**City Council Agenda Item #10
Meeting of Dec. 2, 2019**

Resolution amending Resolution No. 2019-063, preliminary plat of CONIFER HEIGHTS, a six-lot subdivision, at 5615 Conifer Trail and 5616 Mahoney Ave

Resolution No. 2019-063

Resolution amending Resolution No. 2019-063, the preliminary plat of CONIFER HEIGHTS, a six-lot subdivision, at 5615 Conifer Trail and 5616 Mahoney Ave

Figure 1: CONIFER HEIGHTS plat

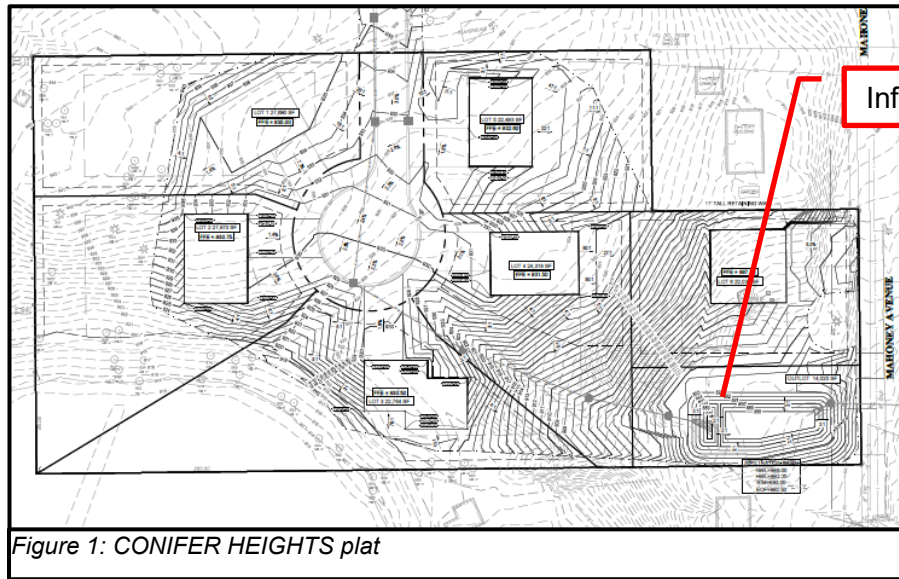
The city council approved the preliminary plat of CONIFER HEIGHTS, a six-lot subdivision at 5615 Conifer Trail and 5616 Mahoney Avenue, on July 22, 2019. The plan included an infiltration basin in the southeast corner of the site intended to comply with the city's stormwater regulations.

Landlocked basin

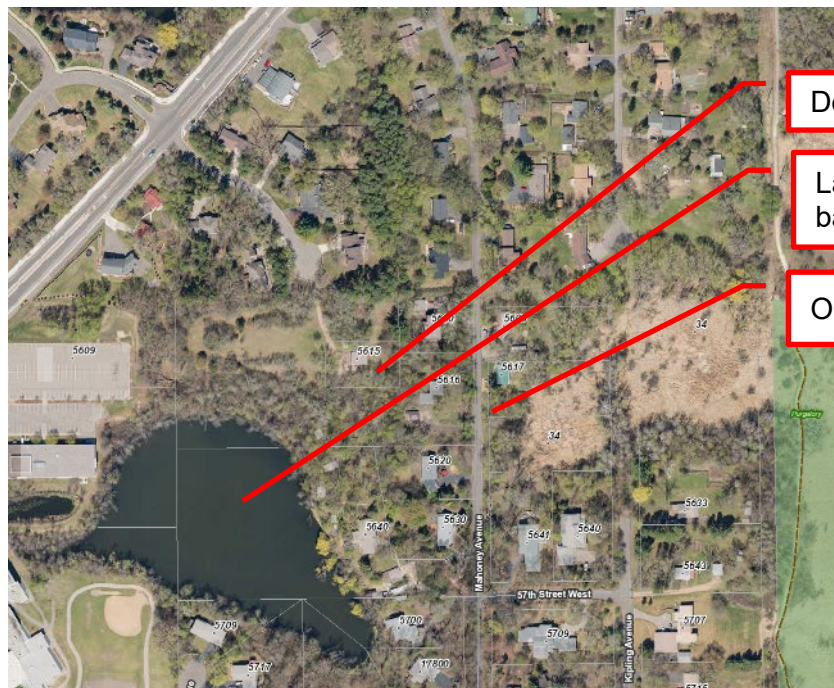
During the initial review of the subdivision, staff identified a possible

opportunity to improve drainage issues by creating an outlet for the landlocked basin on the west side of the site to overflow – via pipe – to the east. The plan to do so was both opportunistic and complicated, and it was unknown at the time of the subdivision if it would be possible to implement it. Staff has continued to work with the developer since the council's last review of the project to further develop the plan.

The developer has offered to install the infrastructure needed for the outlet as part of the site's development in exchange for the city's future maintenance of the stormwater pond. Staff is supportive of this request, as:
